Bureau of Engineering
Report No. 2

October 2, 2024
CD No. 6

REVISE BUDGET AND ISSUE SUPPLEMENTAL AGREEMENT CHANGE ORDER NO. 12 TO SJD&B, INC. FOR THE CAPITAL IMPROVEMENT PROJECT 8654 DONALD C. TILLMAN WATER RECLAMATION PLANT JAPANESE GARDEN AMERICANS WITH DISABILITY ACT COMPLIANCE (WORK ORDER NO. SJD00013, CONTRACT NO. C-139694)

Figure No. 2: Waterfall Viewing Bridge

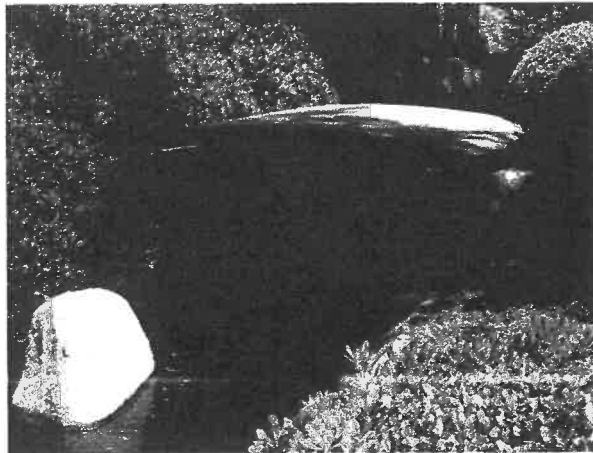
During the demolition of the Waterfall Viewing Bridge, electrical conduits were discovered underneath that were not shown in the project plans. The BCA electrical inspector determined that the conduits needed replacement. Additionally, the existing bridge footings were found to be lower in elevation than specified in the plans, requiring an extension of the footings. This requires a change order with an estimated cost of \$50,000.

In hopes of making overall project progress, the SJD&B Team was allowed to perform the demolition of the Waterfall Viewing Bridge located within the Japanese Garden at the D.C.Tillman Plant. However, it was quickly discovered that there existed a 3-0", 2-0", 1-1/2", & (2) 1-0" electrical steel conduits underneath the bridge which were not shown on the plans. SJD&B scheduled a meeting with the BCA Inspectors and the LADBS Inspector in efforts to solidify how they should proceed. After further inspection, it was deemed that the conduits need to be replaced based on their condition which triggered the need to furnish new electrical plans as well as requiring to pull an electrical permit considering the work would need to be inspected by LADBS inspectors. Additionally, it was observed a pullbox did not exist nearby/within proximity and in order to consolidate the length of wire that would need to be pulled, four (4) pullboxes were proposed to isolate the replacement work. It was also discovered the four (4) existing concrete footings were at a lower elevation than anticipated. A proposal was made to raise the existing footings to the necessary/desired elevation to where the footings would match the concrete end cap's elevation for which the inspectors approved the proposal. LADBS inspectors requested all proposed changes/resolutions be recorded via the project plans.

The revised structural plan sheets SF02 & SF03 are attached and are also provided in Plan Clarification #009 (Linked).

The revised electrical plan sheets EP03 & EP04 are attached and are also provided in Plan Clarification #011 (Linked).
